# City of South Gate

# Volume 2

## Appendix B Facilities Barrier Assessment Report

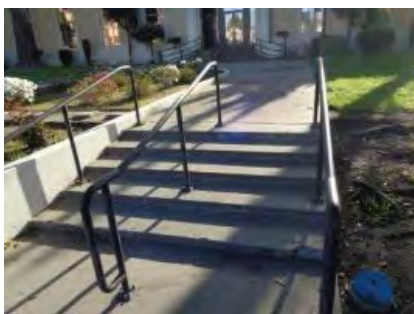
**Findings:** Warning stripes have not been provided for all stairs from the city sidewalk at California Avenue to the Main Entrance of City Hall.

**Recommendations:**  
The upper approach and all treads of each exterior stair shall be marked by a stripe of clearly contrasting color, 2" to 4" wide, placed parallel to and not more than 1" from the nose of the step or landing to alert the visually impaired. The stripe shall be of material that is at least as slip resistant as the treads of the stair. A painted stripe is acceptable.

**Comment** CHL-002 **Priority: 1** **Estimated Direct Cost:** \$1,140 **Maintenance**

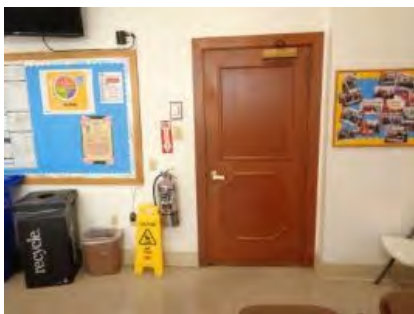
**Item Description:** Door closers;

**Findings:** All doors with automatic closers require adjustment for opening force and closing speed.

**Comment**      **CHL-003**      **Priority: 1**      **Estimated Direct Cost:**      \$600      Maintenance

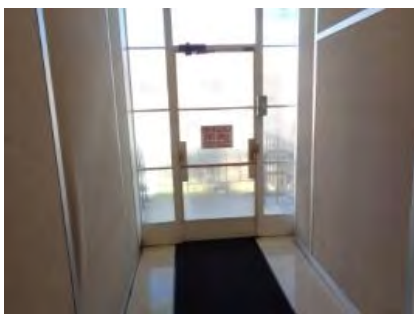
**Item Description:**      Tactile exit signs;

**Findings:**      Tactile exit signs are not provided at all exit doors.

Provide tactile exit signs at all exit doors leading to the exterior via stair or ramp. Mount signs at the latch side of the single doors and preferably to the right of double doors. Signs shall have Grade 2 Braille beneath raised text stating either "EXIT STAIR DOWN or "EXIT RAMP DOWN" as appropriate".

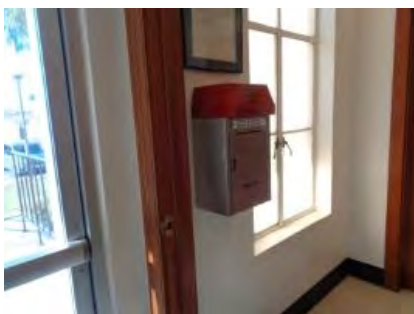
**Item Description:**      Room Identification signs;

**Findings:** The required tactile room I.D. signs are not provided at various rooms. The existing room ID signs have federal braille font which does not conform to California Braille requirements. All existing room ID signs shall be replaced.

**Recommendations:**  
Provide a sign package for all rooms where the use or name of the rooms are not likely to change over time. Signs shall have Grade 2 Braille below raised text.

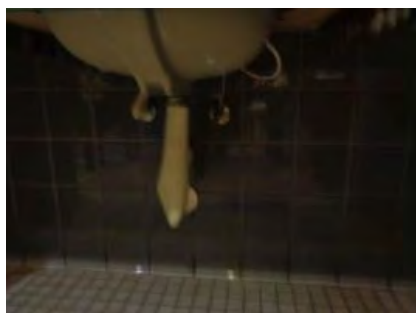
**Findings:** Dispenser is not accessible due to height. Dispenser is not compliant as it require use of two hands and requires tight grasping and pinching. The side wheel for advancing paper requires twisting of the wrist.

**Recommendations:**  
Remove and replace paper towel dispenser. New dispenser shall not require tight grasping, pinching or twisting of the wrist. Mount new dispenser not higher than 40" AFF to the highest operable part.
